March 29, 2022

RE: Design Review Application Project Address: 7950 Bodega Avenue

|    | Prelim Design Review Comments  | Response  |

A1.0

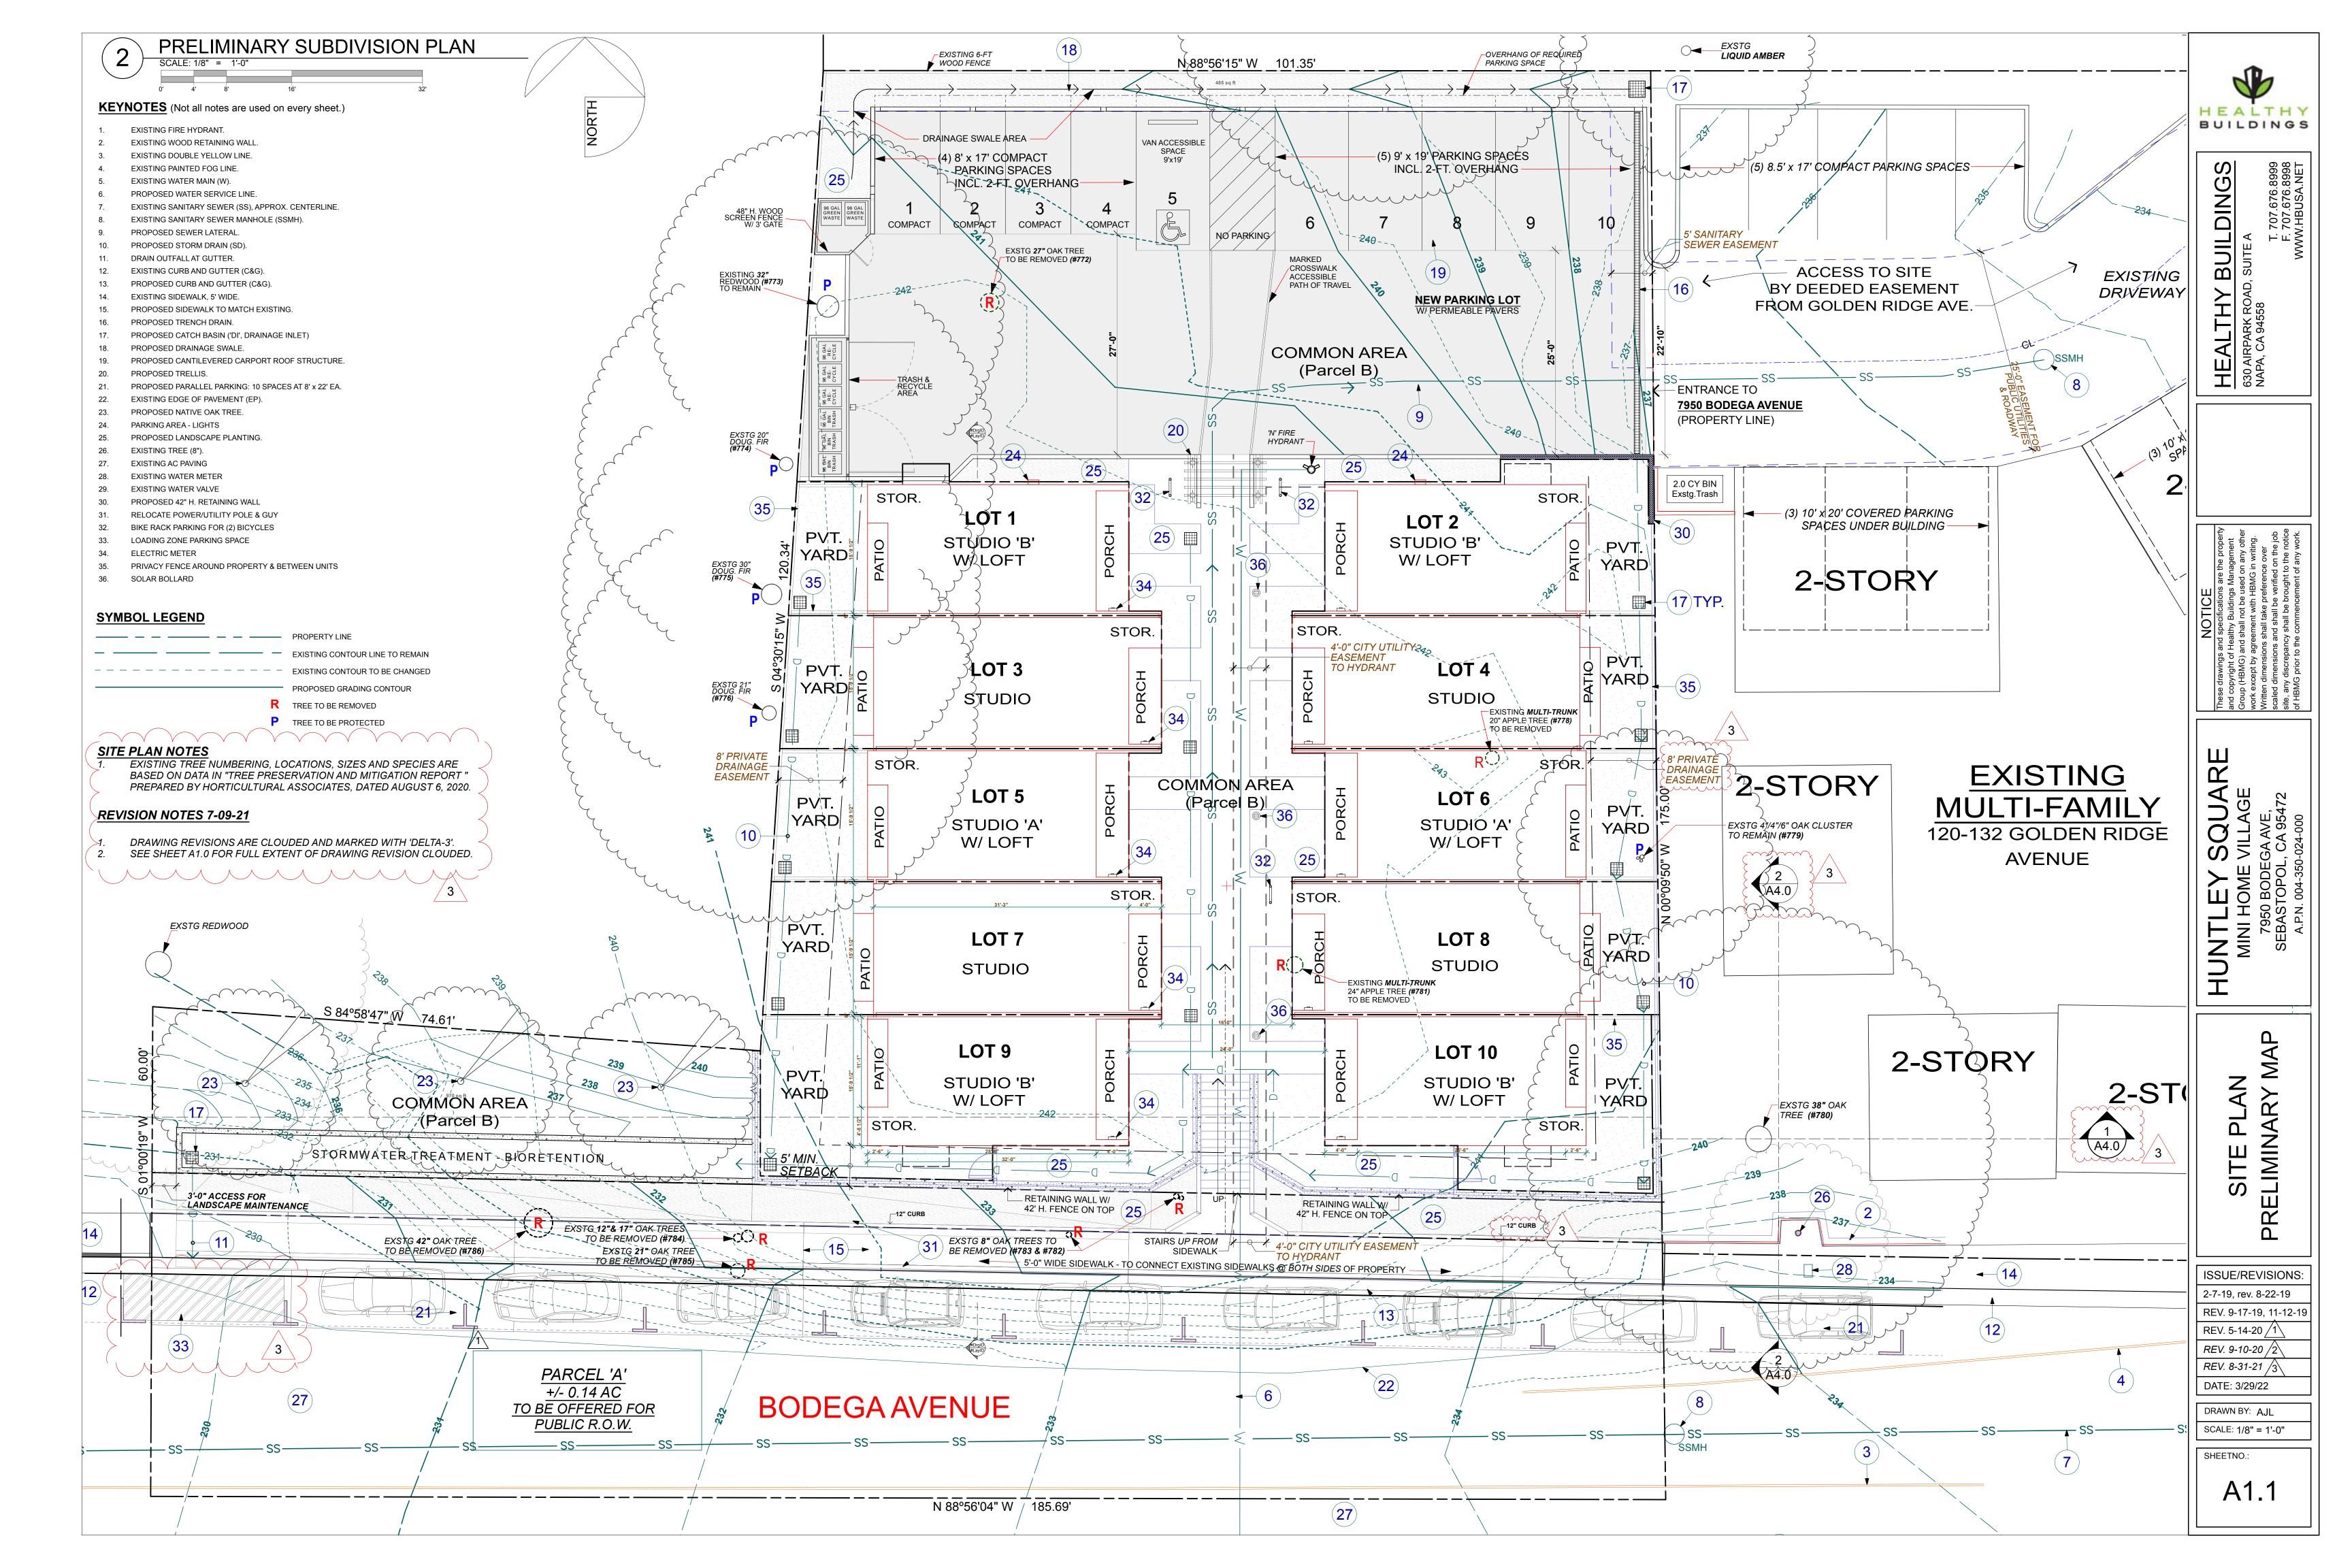
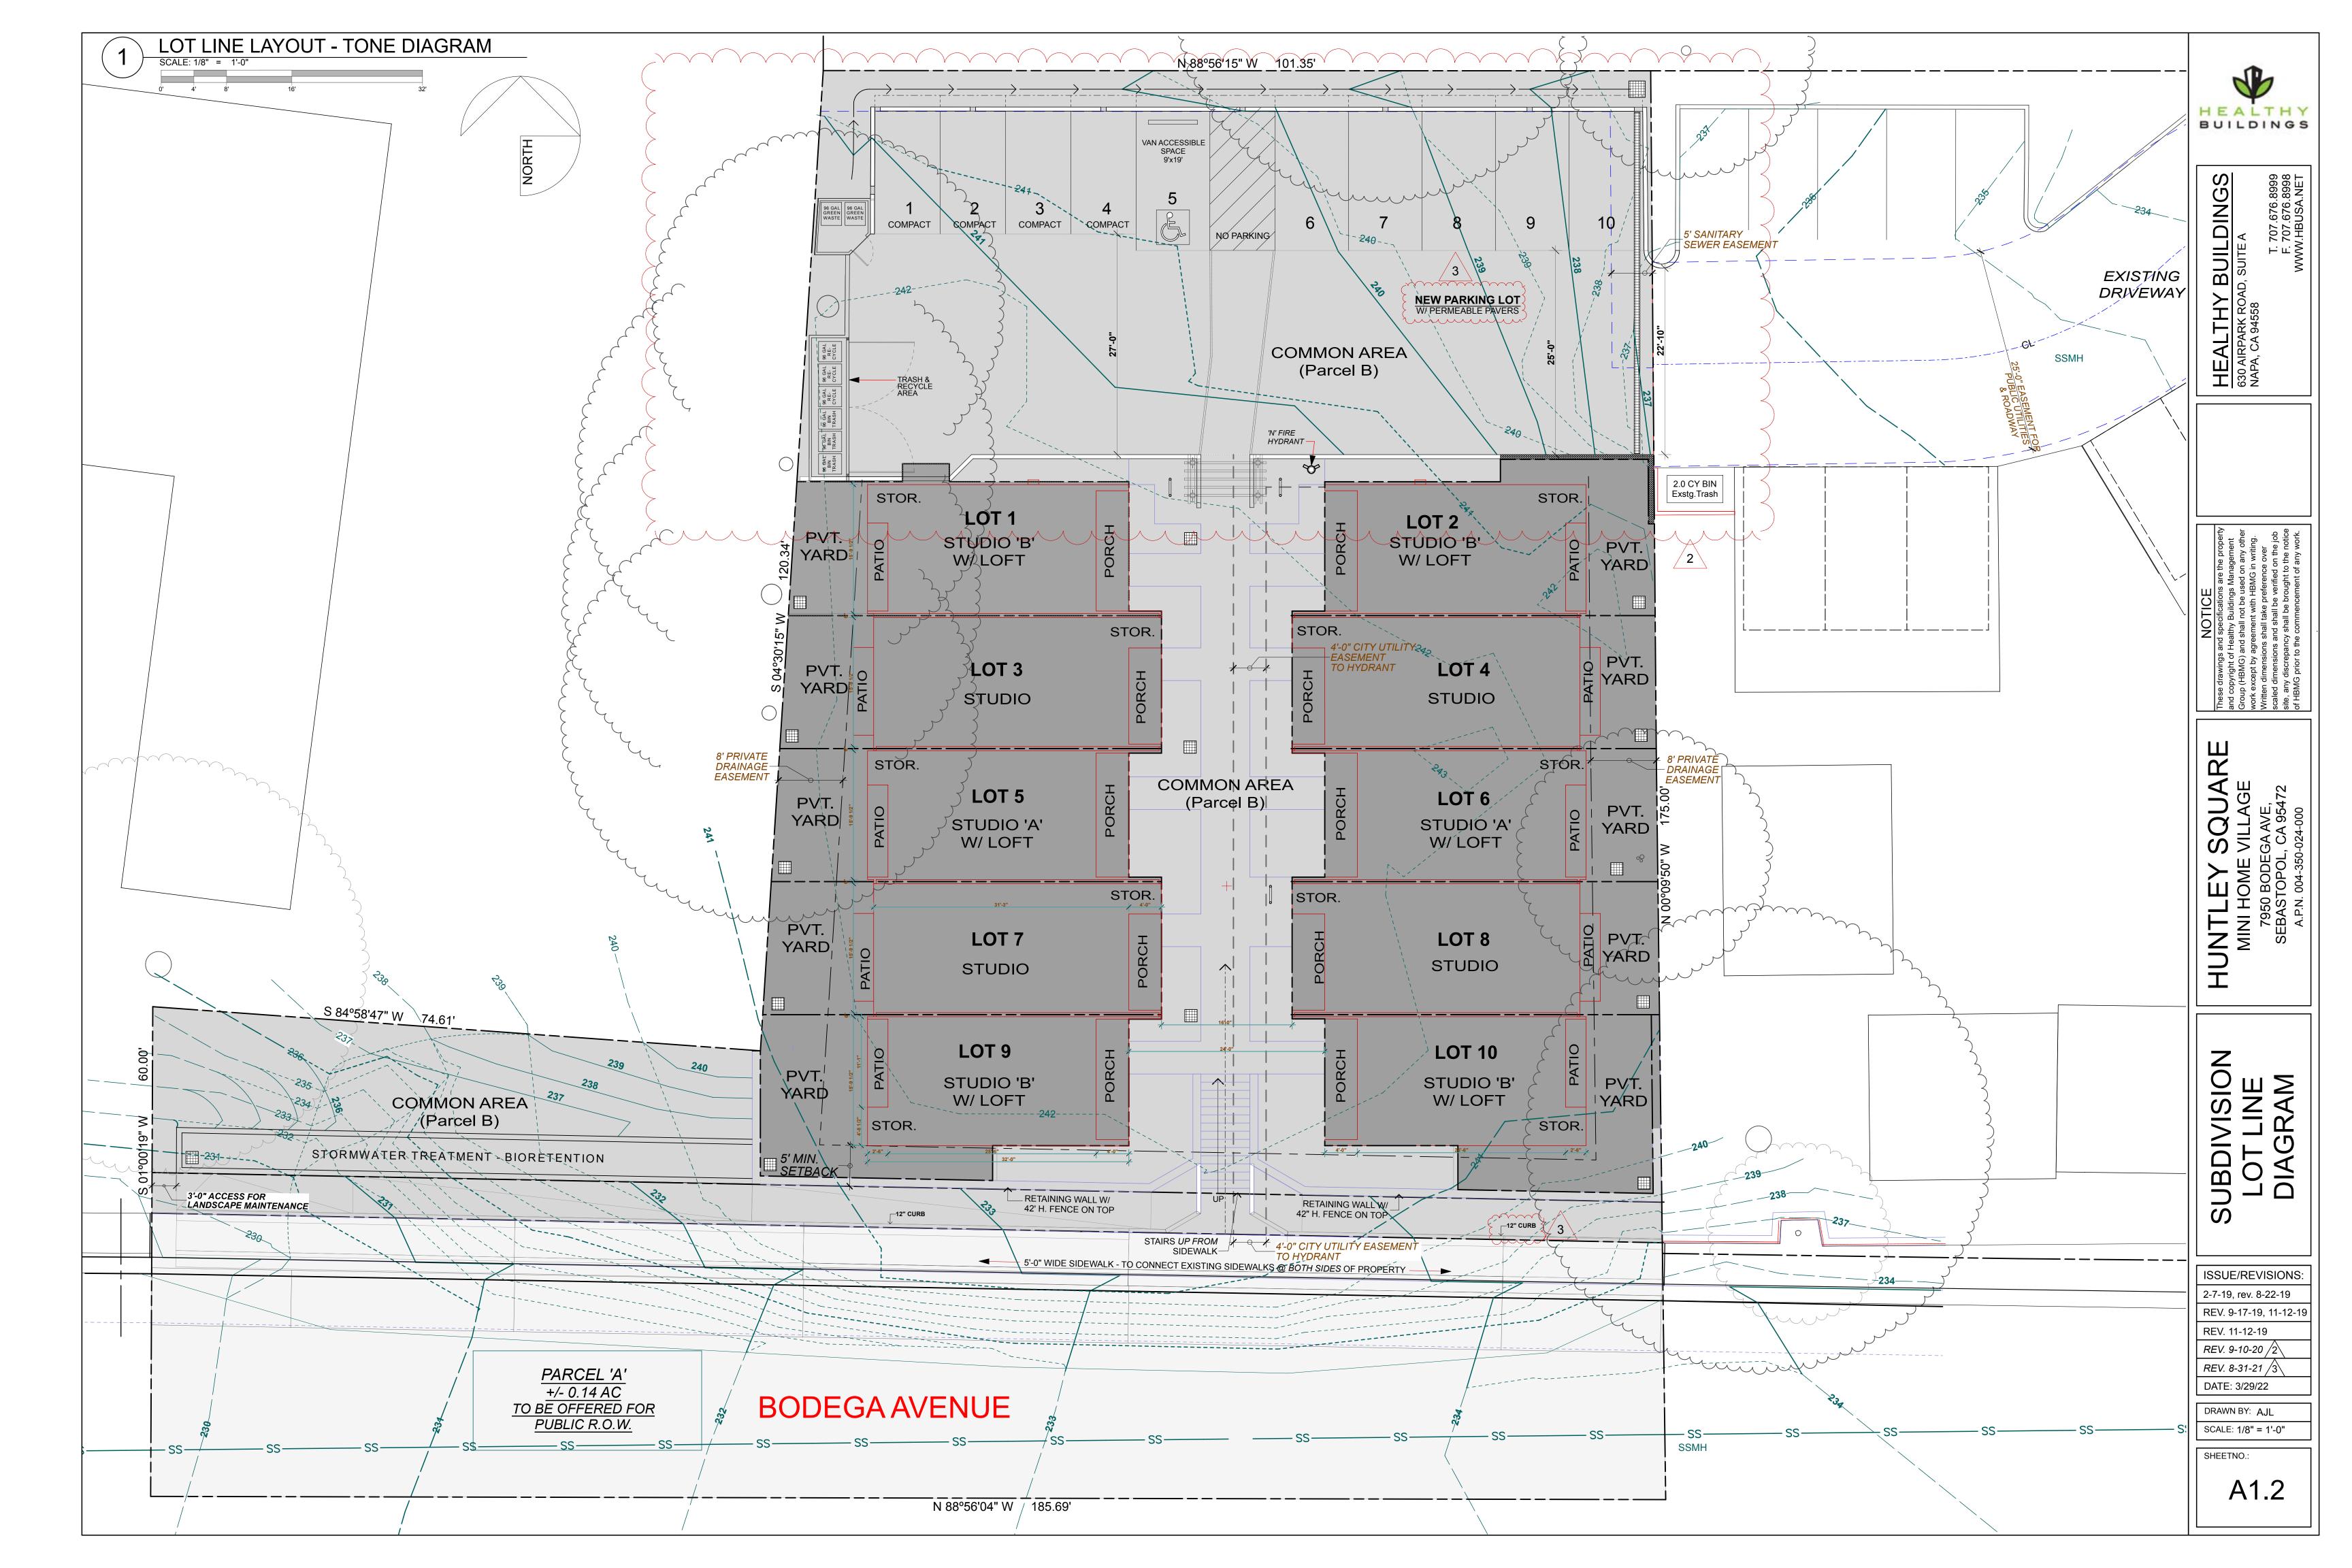
|    | Prelim Design Review Comments  | Response  |
|----|--|---|
| 6  | Plan showing driveway on easement at neighbors property to the east.                                       | Sheet A1.0 and A1.1 shows how the parking area is accessed over the easement on the neighbors property. The easement is 25' wide and the entrance to the new project parking area is 22' wide.  |
